REPORT  
OF  
THE ADVISORY COMMITTEE  
ON  
HIRAKUD DAM PROJECT

MARCH 1952

# REPORT OF THE ADVISORY COMMITTEE ON HIRAKUD DAM PROJECT (MARCH 1952)

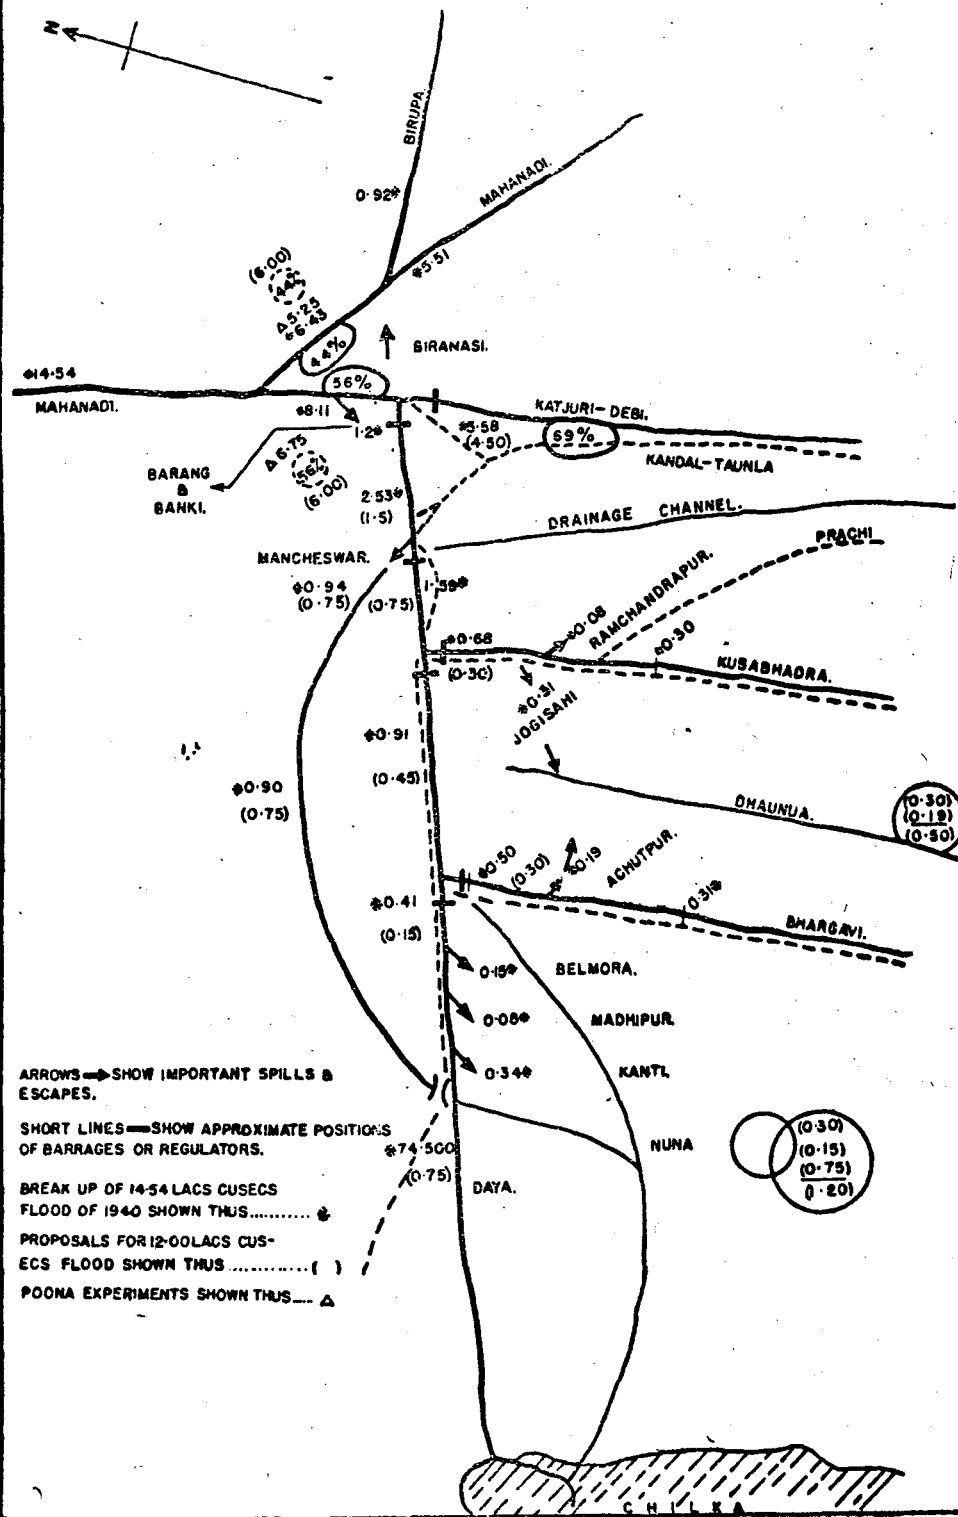
These figures show that at high flood of 14.54 lakh cusecs, Mahanadi takes 44% and Katjuri 56%. The Poona Experimental Station found that at 12 lakh cusecs flood also the distribution will be of the same order. These figures are shown in red, in the plan.

8. The figures in yellow represent the discharges which should be pushed in each channel, with a 12 lakh cusecs flood. Regulation of these discharges to the figures proposed now, is to be done with the help of the barrages which are proposed now, and which are shown roughly on the plan. It will be seen that the distribution of relief, contemplated in paragraph 5 above is roughly achieved with this arrangement.

GOVERNMENT OF INDIA CENTRAL WATER & POWER COMMISSION		
HIRAKUD DAM PROJECT PART ORISSA DELTA 5 FEET-CONTOUR MAP SHOWING ACTIVE STREAMS & DRAINAGE LINES		
CHIEF ENGINEER & MEMBER DESIGNS		
	HIRAKUD MARCH, 1952

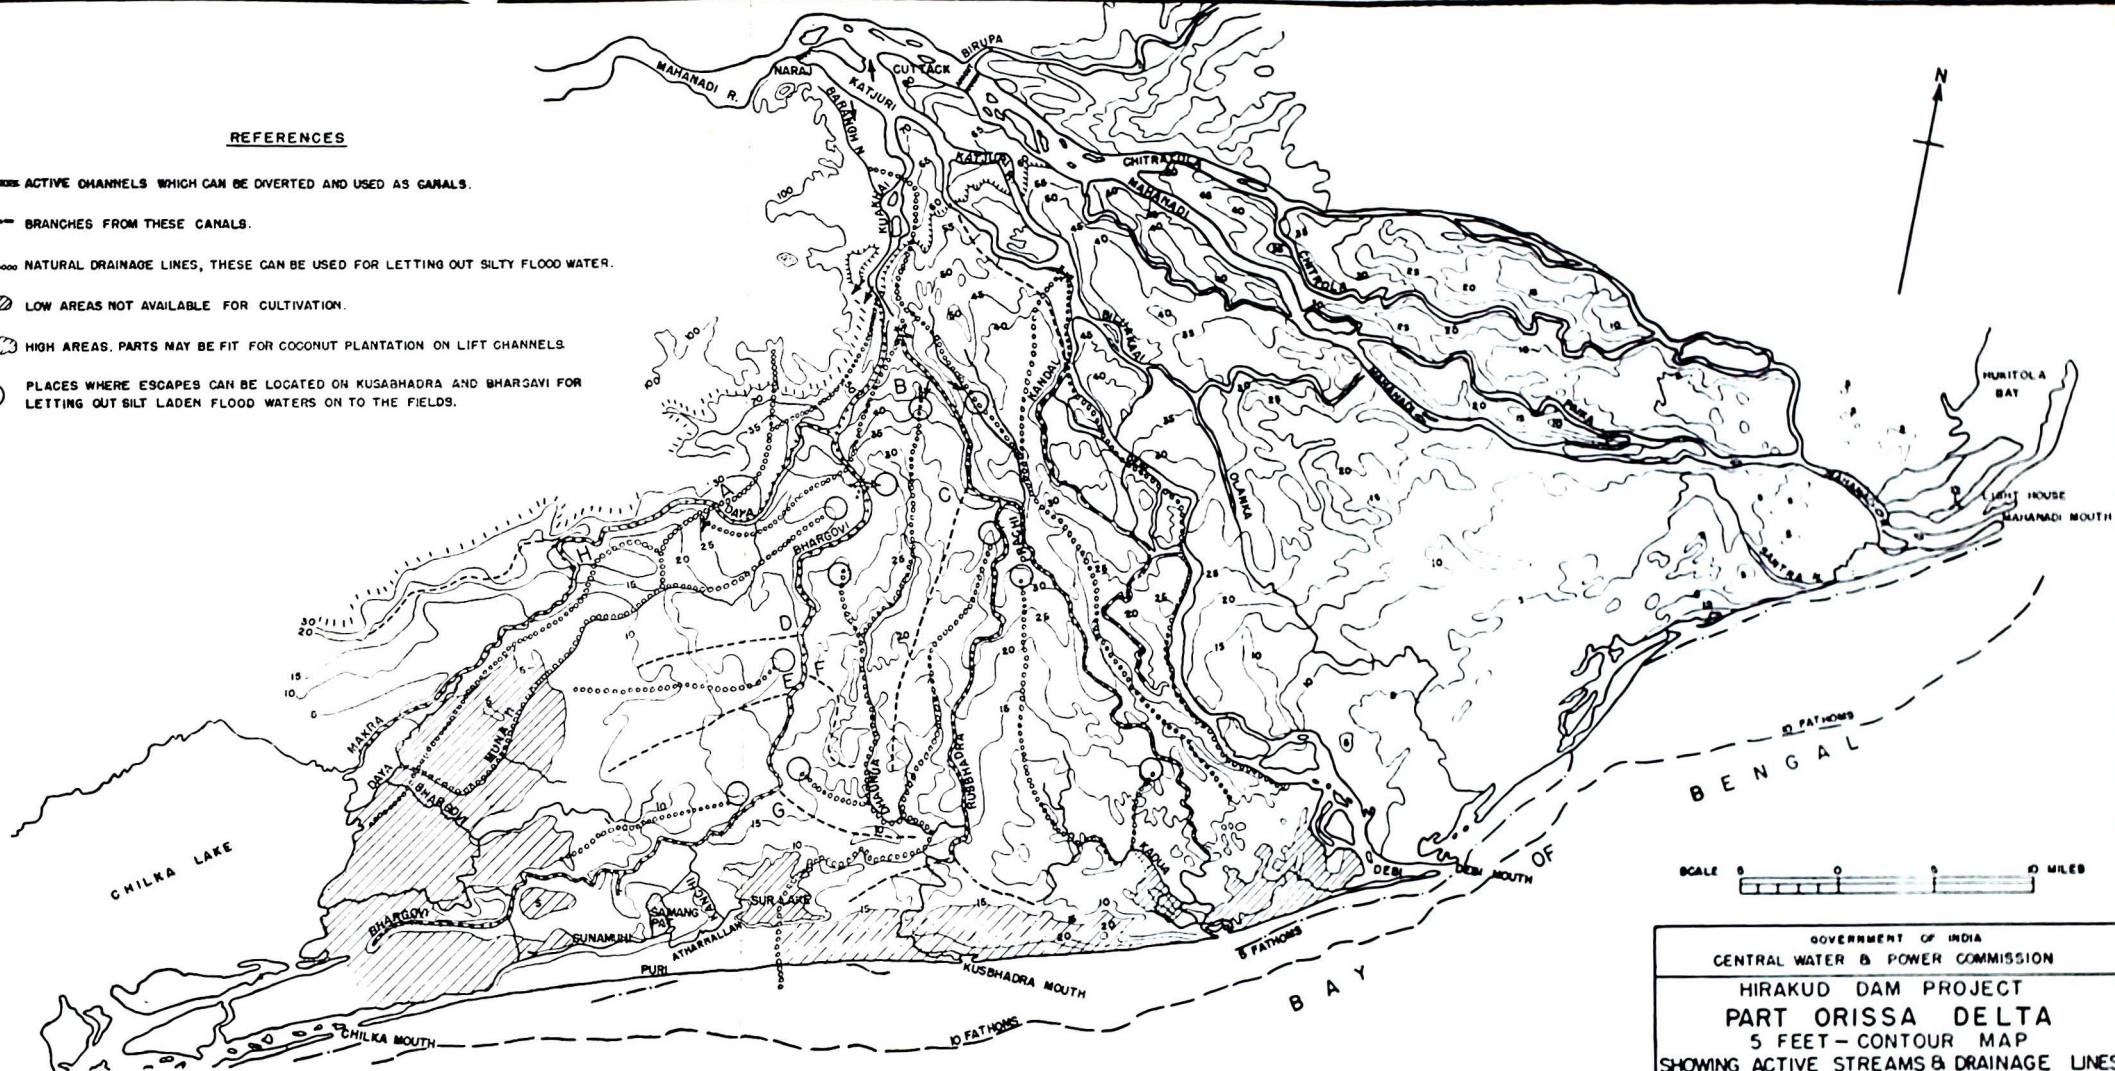
13. Prachi can be used as a branch off Kushabhadra. Another branch can be thrown from Kushabhadra from point.
